**SUNDRY NOTICES AND REPORTS ON WELLS**  
*Do not use this form for proposals to drill or to re-enter an abandoned well. Use Form 3160-3 (APD) for such proposals.*

8 Well Name and No LENTINI 1 FEDERAL #1

2 Name of Operator Chevron U.S.A. Inc.

**WELLBORE DIAGRAM  
LENTINI 1 FEDERAL #1  
PROPOSED**

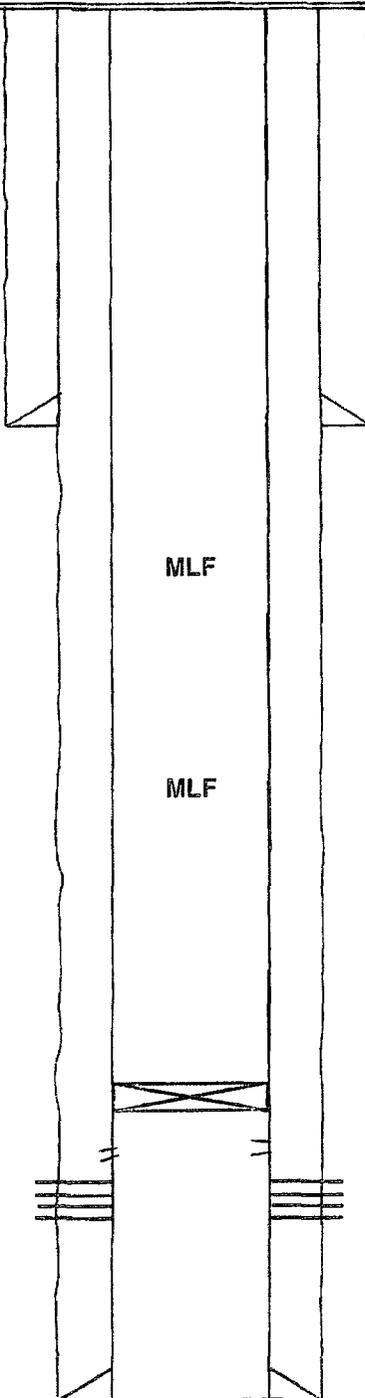
*ASLr 201  
 TOS 493  
 BOS 2511  
 Del 2743  
 BS 6271*

Spot 25sx of Class "C" Cement from 2561' 2361'. (B.Salt) *WOC + tag*
